ENGINEERING CHANGE NOTICE

Originator: Harsh Patel Phone No.: (416) 754-3322 Email Address: Hpatel@edac.net Department: ENGINEERING	Date:	Document Number
	April 29, 2021	ECN20210429-00
	Revision Number	SHEET
	1	1 of 2

Waterproof USB dust cover (with plastic chains)

ACAD REFERENCE NO.: M00-383-001

REASON OF CHANGE

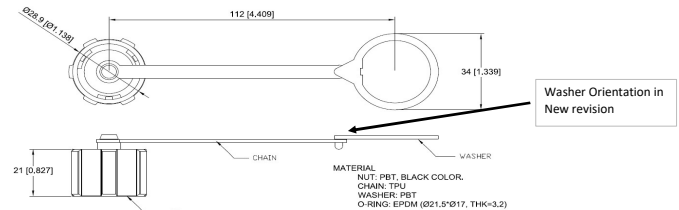
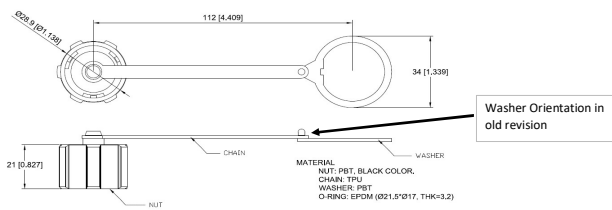
Improvement done for M00-383-001(Waterproof USB dust cover with plastic chains) so that Plastic chain won't be twisted when being fitted in the connector.

- Washer Orientation Changed (Improvement) so that Plastic chain will not be twisted when being fitted in the connector.

Old Drawing No
M00-383-001, Rev-01

New Drawing No
M00-383-001, Rev-02

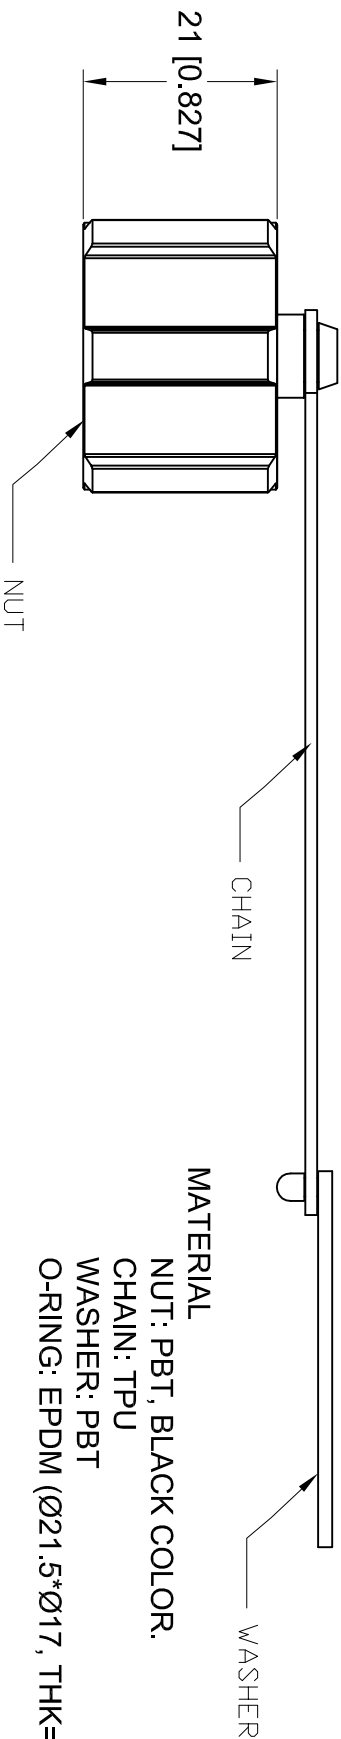
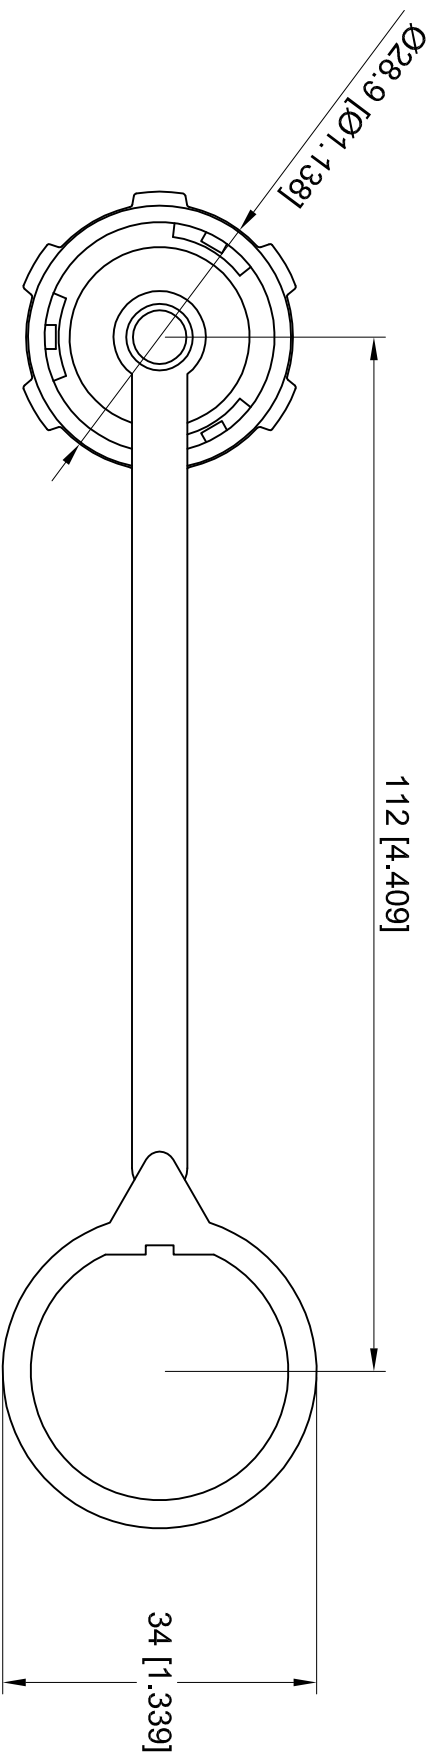
ISSUE NUMBER	ORIGINAL	①
CHANGE WASHER ORIENTATION		
P.M.	APR. 27/2021	②
